Re: Approval to Conduct On-Site Wastewater Treatment and Irrigation
Falcon Refinery
1472 FM 2725, San Patricio County, Ingleside, Texas 78362
SUP111

INTEROFFICE MEMORANDUM

Subject: National Oil Recovery Corporation (NORCO), Falcon Refinery Superfund Site (the facility)

WATER TREATMENT AND IRRIGATION SYSTEM

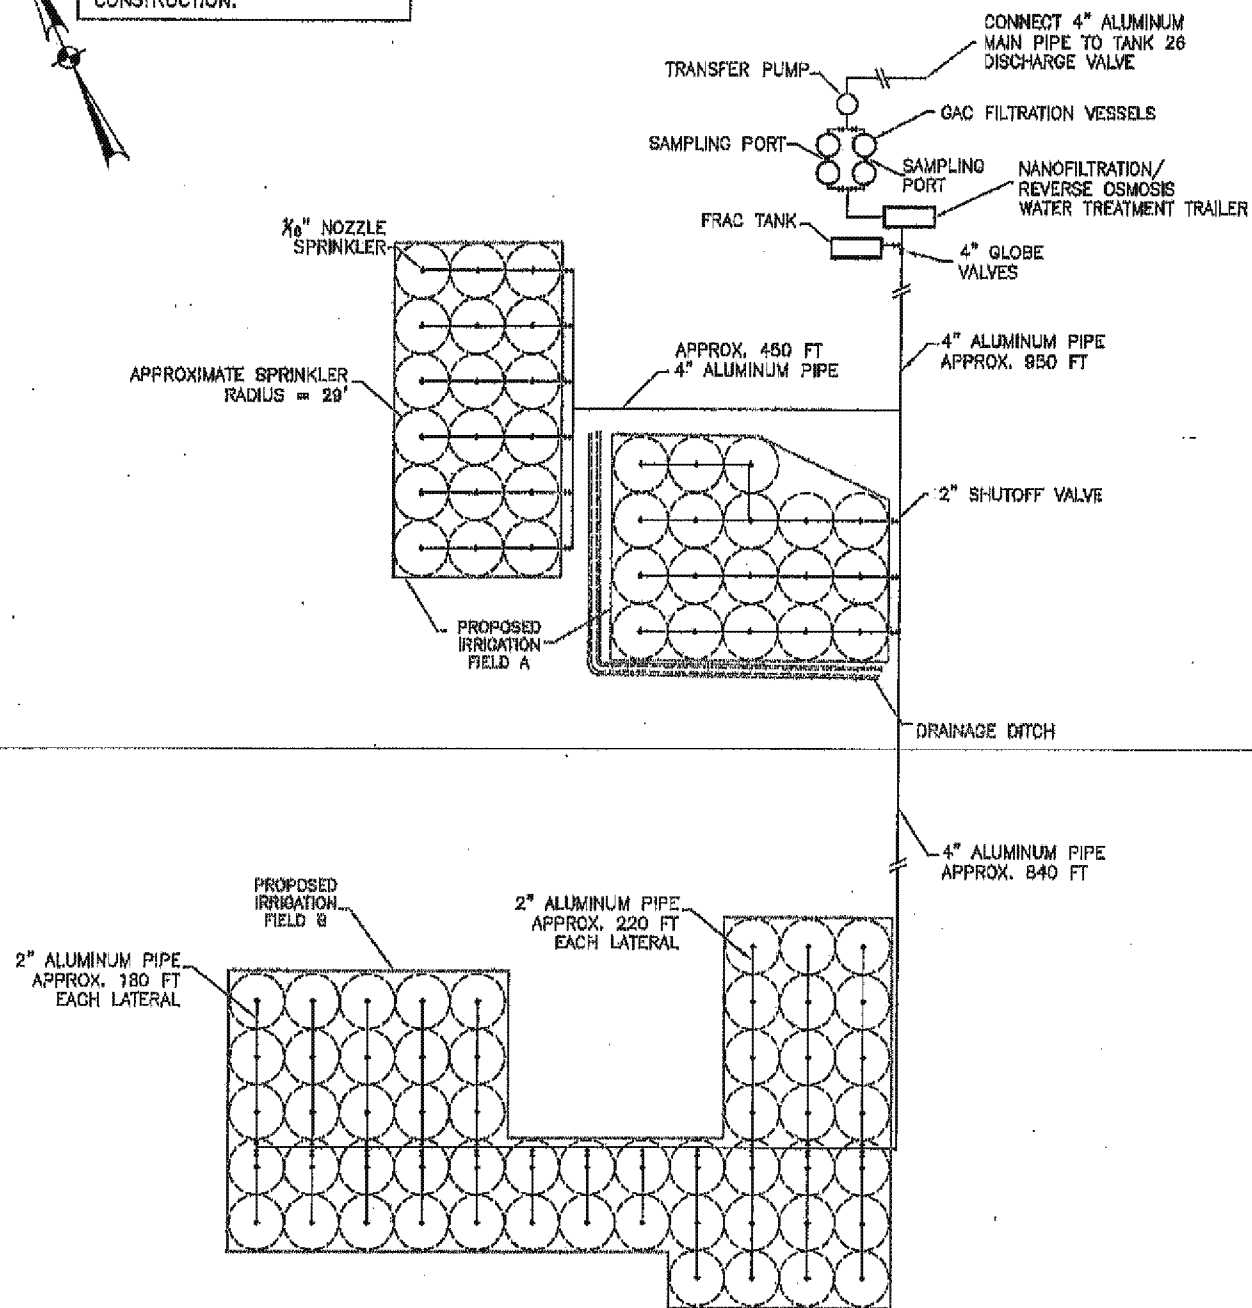
7. The irrigation system shall be constructed in accordance with the conceptual design provided in Attachment C.
 8. The quality and the loadings of the treated wastewater shall be maintained as follows:
 - a. hydraulic loading: ≤ 3.18 inches per acre per month (in/ac/month)
 - b. daily maximum effluent flow: $\leq 15,649$ gallons per day (0.015649 MGD)
 - c. daily maximum total nitrogen loading: ≤ 0.436 lbs/acre/day
 - d. conductivity: < 4.0 milli-Siemens per centimeter (mS/cm)
 - e. pH: between 6.0 and 9.0 standard units.
-
